**MONTGOMERY COUNTY HISTORIC PRESERVATION COMMISSION**  
**STAFF REPORT**

<b>Address:</b>	11650 Snowden Farm Pkwy., Germantown Formerly 22022 Ridge Rd.	<b>Meeting Date:</b>	9/3/2025
<b>Resource:</b>	Master Plan Site #13/19 <i>Howes Farm</i>	<b>Report Date:</b>	8/27/2025
<b>Applicant:</b>	NECC	<b>Public Notice:</b>	8/20/2025
<b>Review:</b>	HAWP	<b>Tax Credit:</b>	n/a
<b>Permit Number:</b>	1109684	<b>Staff:</b>	Dan Bruechert
<b>Proposal:</b>	Demolition and reconstruction of barn/accessory building

# Responses to HPC Comments/Recommendations during the consultation meeting held July 9, 2025

1 SOUTH ELEVATION  
1/4" = 1'-0"

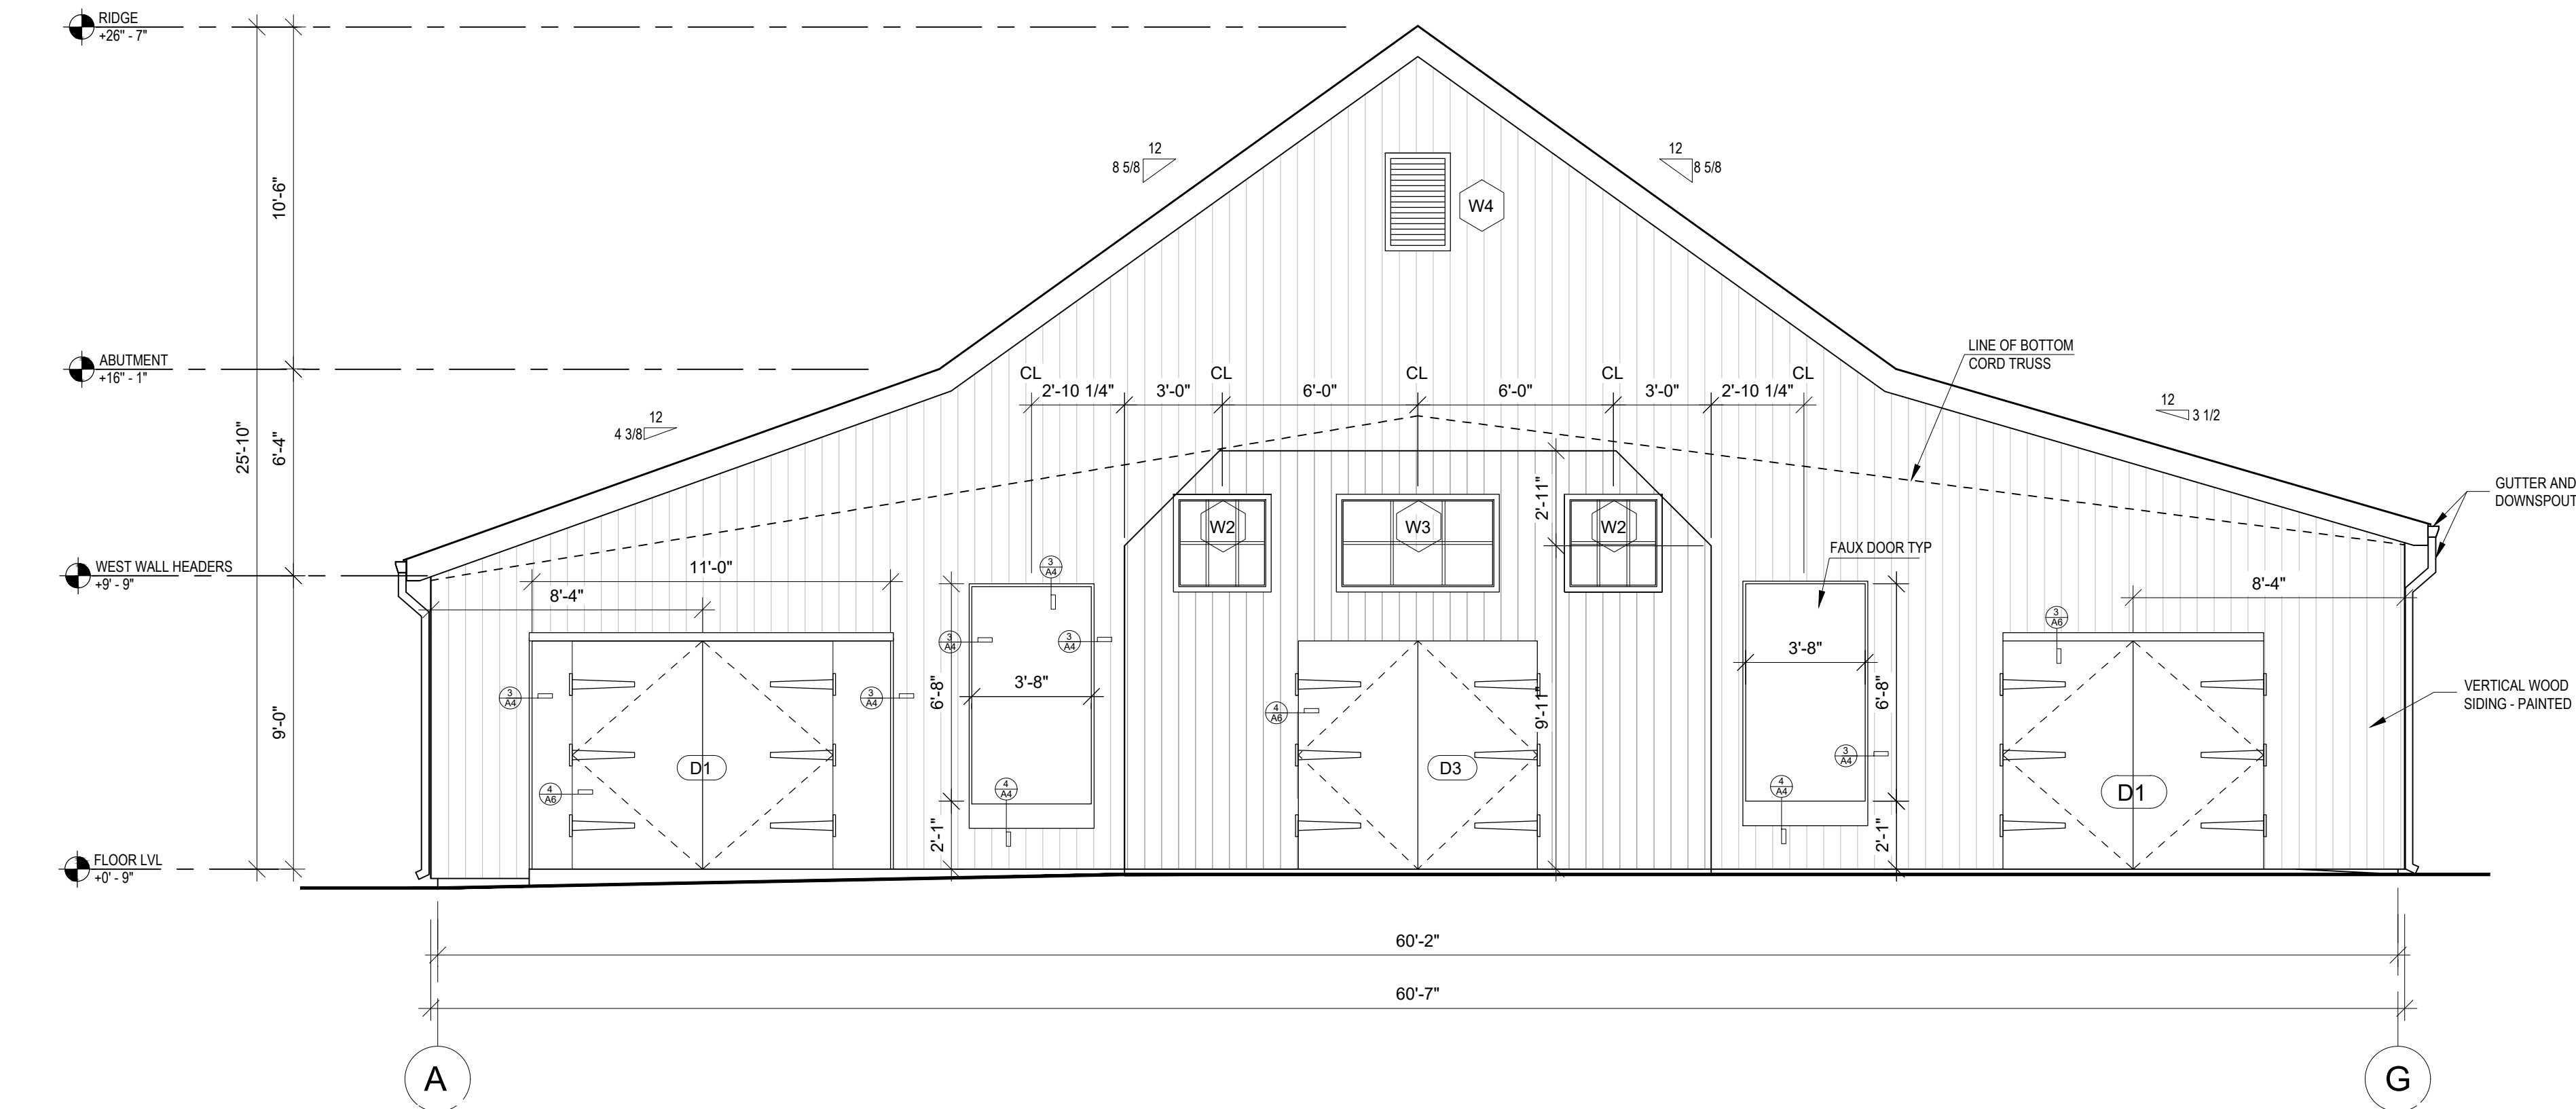
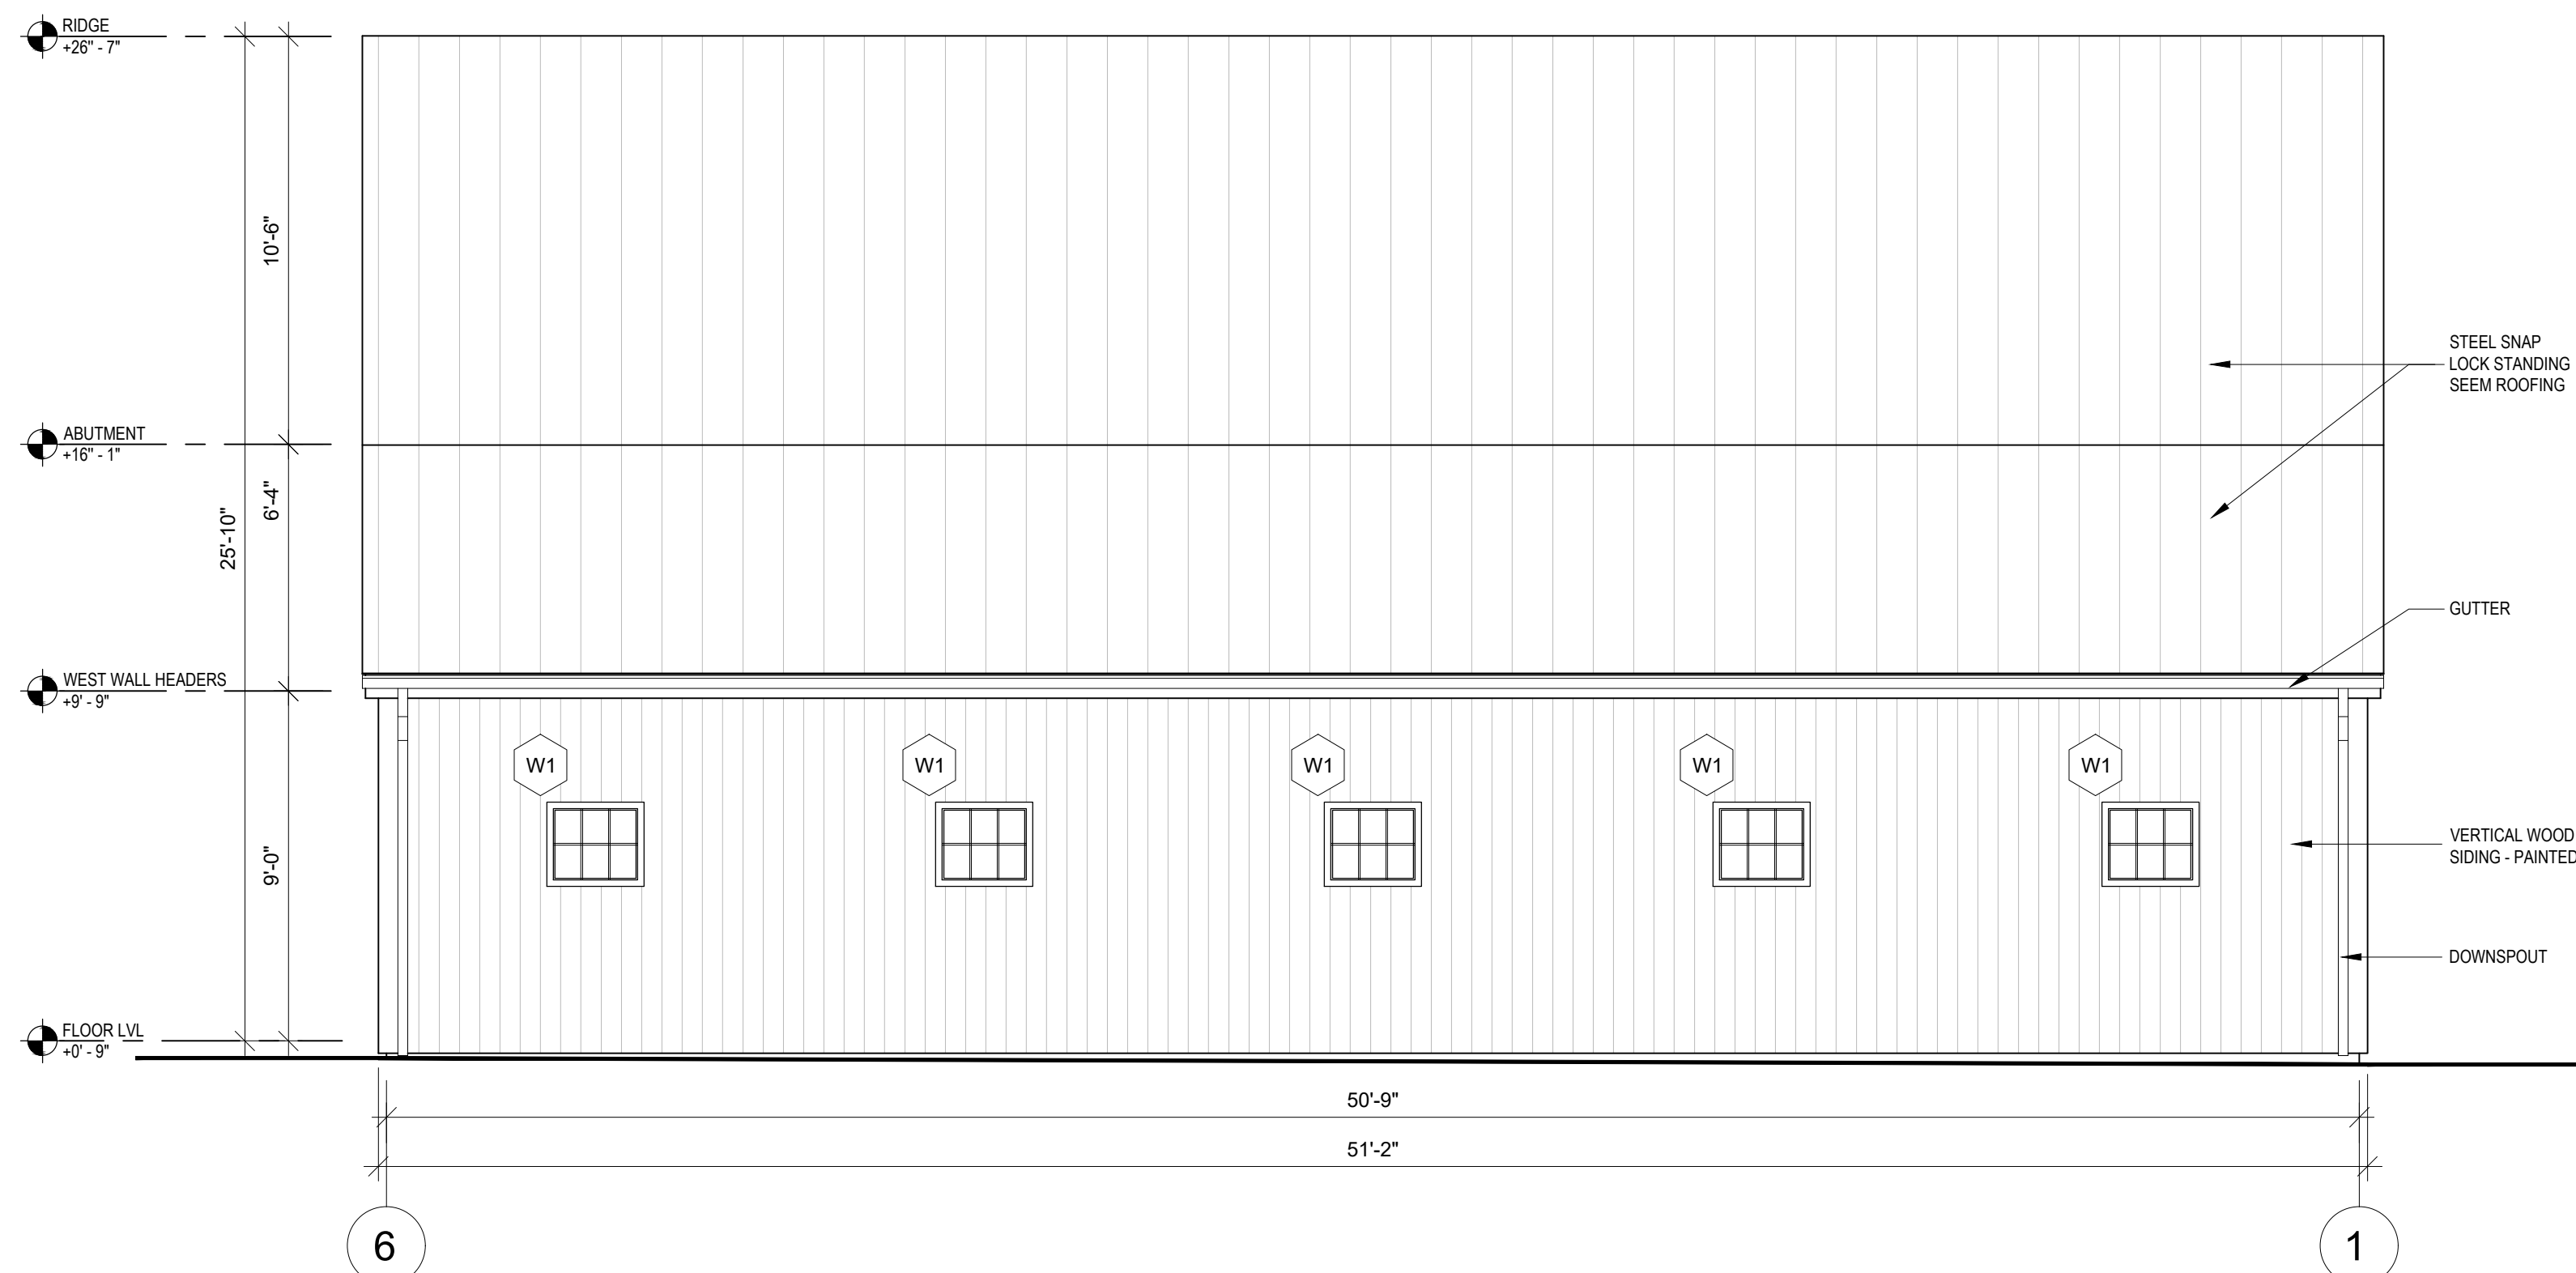
## HPC Comment 2: Roof Slope

## HPC Comment 3: Windows and Doors

NECC: We have made revisions to the drawings to match the existing roof slope. Please refer to drawing sheets A2 for demolition drawing, and A4 and A5 for new elevations and cross sections.

- Doors /windows details are provided with this submittal, refer the sheets A4, A5, and A6 for details.

- As per HPC recommendations, roof slopes have been revised to match the existing roof slopes. Refer the sheets A4, A5, and A6 for details.
- Description of proposed roofing materials can be found here: <https://www.abmartin.net/metal-roofing-panels/abseam>.
